29037/L090619

**Re: Part Lot 222 & Lot 224 DP 862015, Waterfront Road, Swan Bay – MP07\_0041**

Further to the Department of Planning's letter of 3 June 2009 (Bright, Wells) we have provided the following response to the four issues raised in the letter.

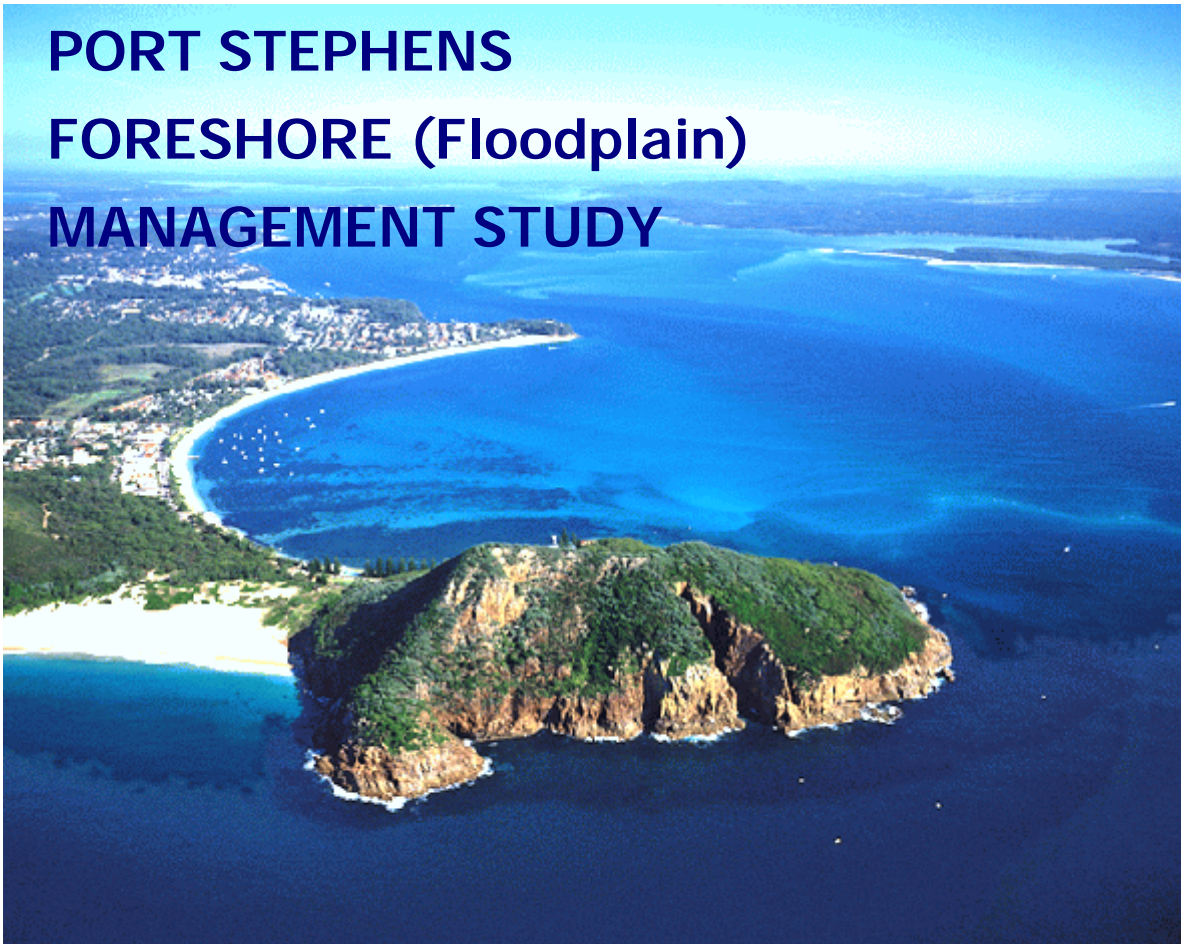
**4. Any supporting plans/RLs should be referenced to AHD.**

An indicative tidal range at Swan Bay is from -0.7 m AHD to +0.7m AHD. The maximum annual tidal (i.e. with no ocean anomalies) level at Swan Bay would be approximately 1.1 m AHD. The surveyed ground levels (see attached) indicate typical ground levels of 1.5 m AHD, thus the existing ground is approximately 0.4 m above the maximum annual tidal level.

Please find attached the site plan prepared by a Registered Surveyor with all levels to AHD.

FIGURE 5

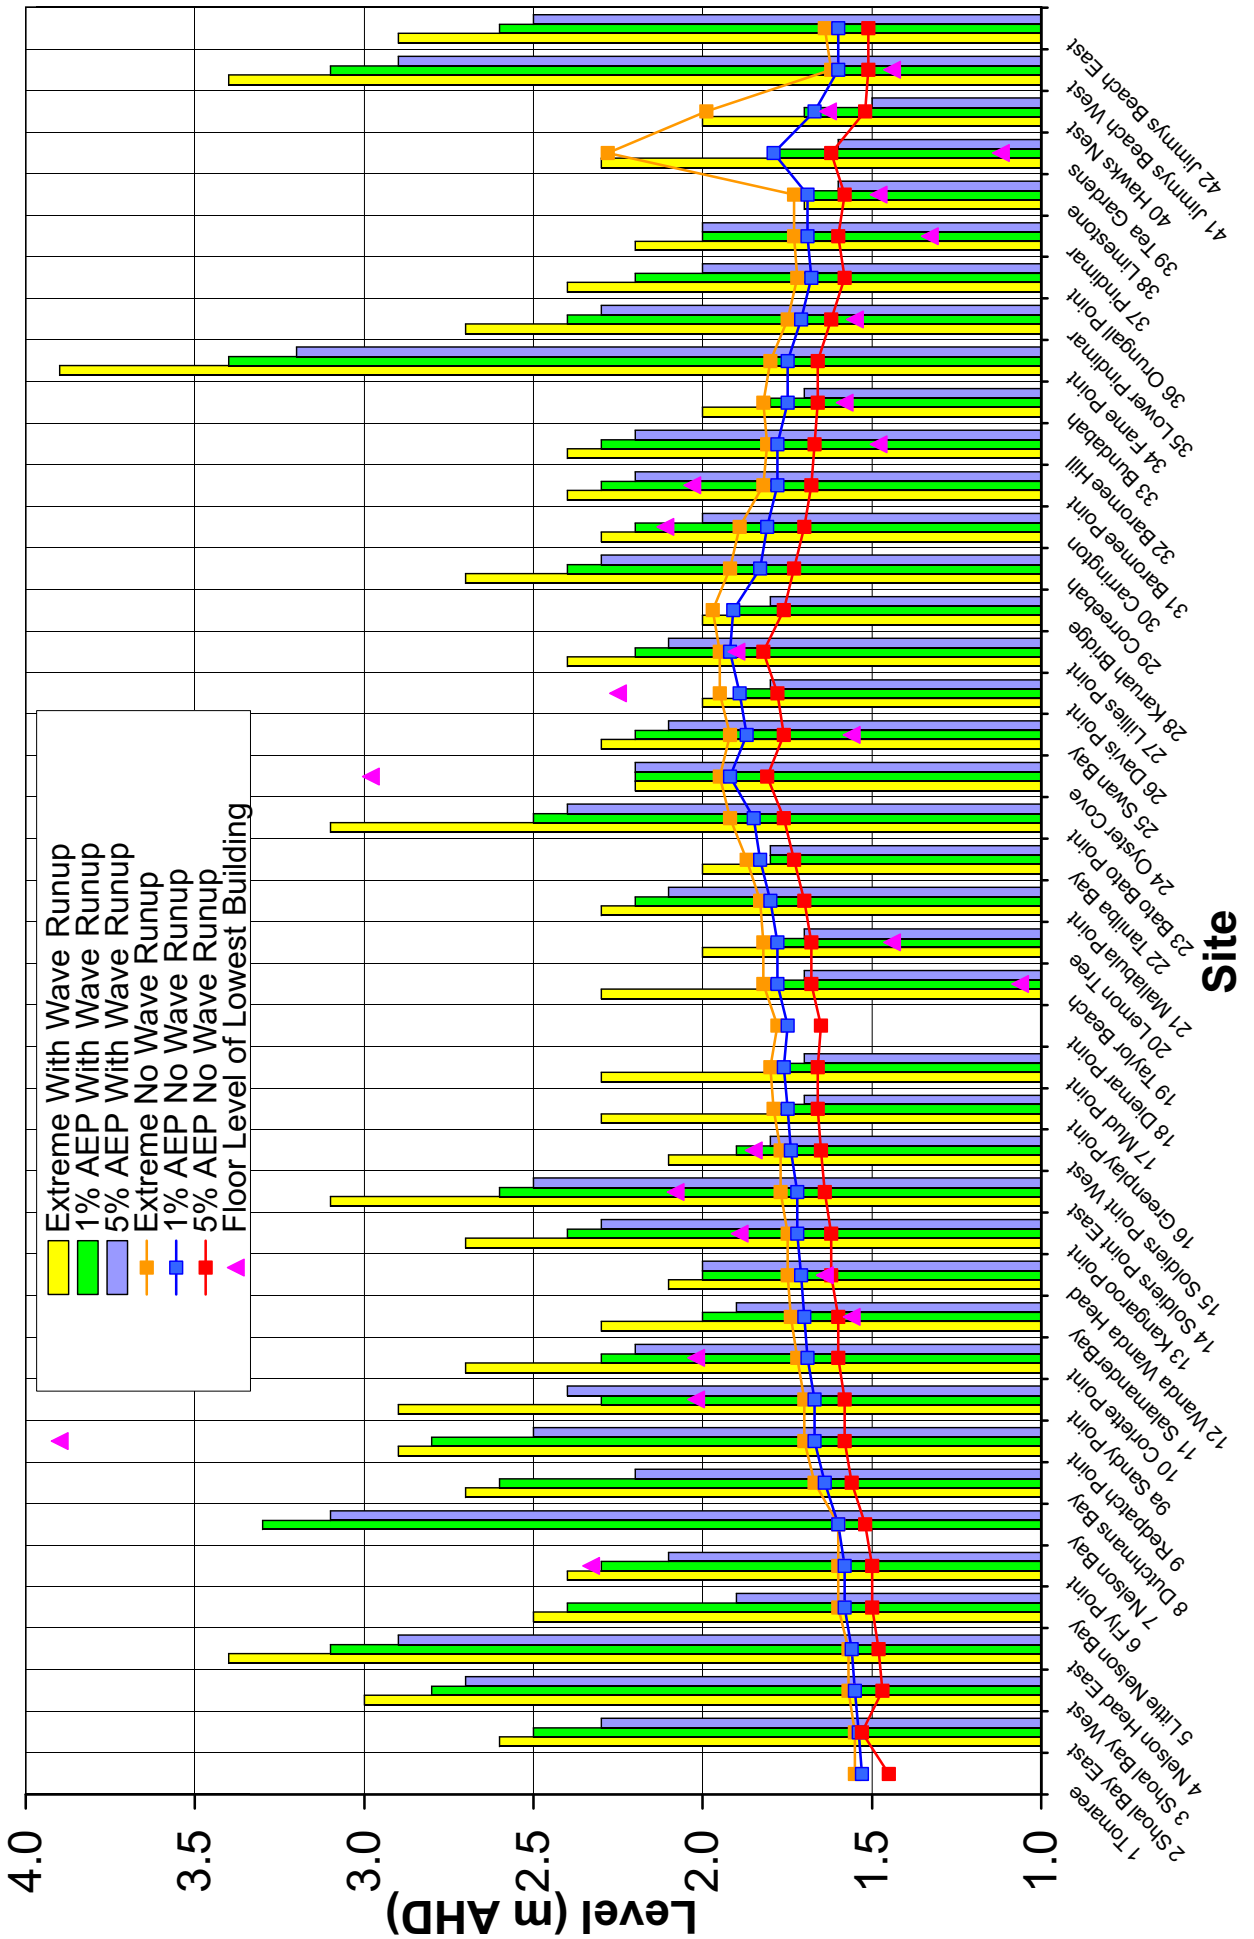
**2. Investigate the effects of tidal range, and inflows from the Karuah River**

The inflows from the Karuah River have been considered in establishing the design flood level of 1.9m AHD and this is the reason why there is a flood gradient from west to east in the estuary (refer Figure 5).
